Stage 1 Road Safety Audit Report

Mayo County Council

May 2025

N58 STRADE RIVER BRIDGE REHABILITATION WORKS

Figure 2.1 – Safety Barrier Partially Obscuring Sight Lines at The Davitt Museum Access

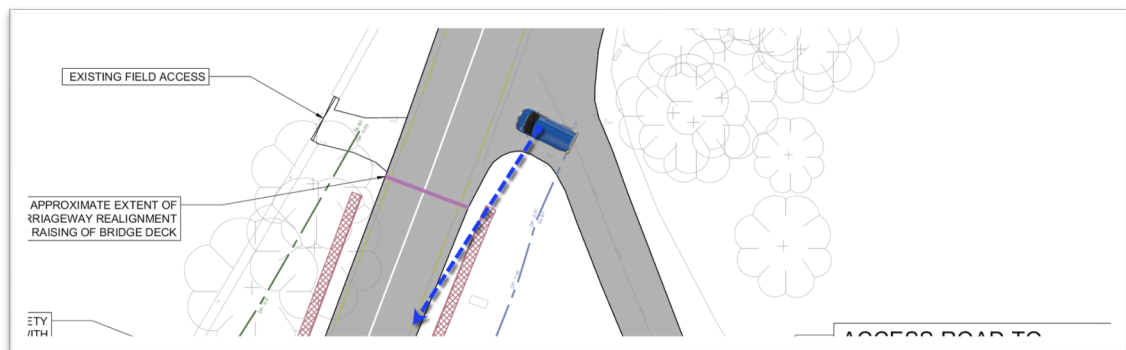
2.1 Problem: Safety Barrier Partially Obscuring Sight Lines

Location: Accesses on Either Side of Strade River Bridge

The proposed safety barrier may partially obscure drivers' sight lines at the Davitt Museum access, potentially increasing collision risks on the N58.

Assess sight lines at the access and adjust the safety barrier (if required) to optimize visibility.

| Problem Reference (Section 2) | Designer Response Section | | | Audit Team Response Section |
|----------------------------------|----------------------------------|--|---|---|
| 2.1 | Yes | Yes | Sightlines have been assessed with the ends of the safety barriers on the northwest departure and northeast approach to be flared to avoid impact on sightlines from the field access and the junction to the museum. | Noted. |
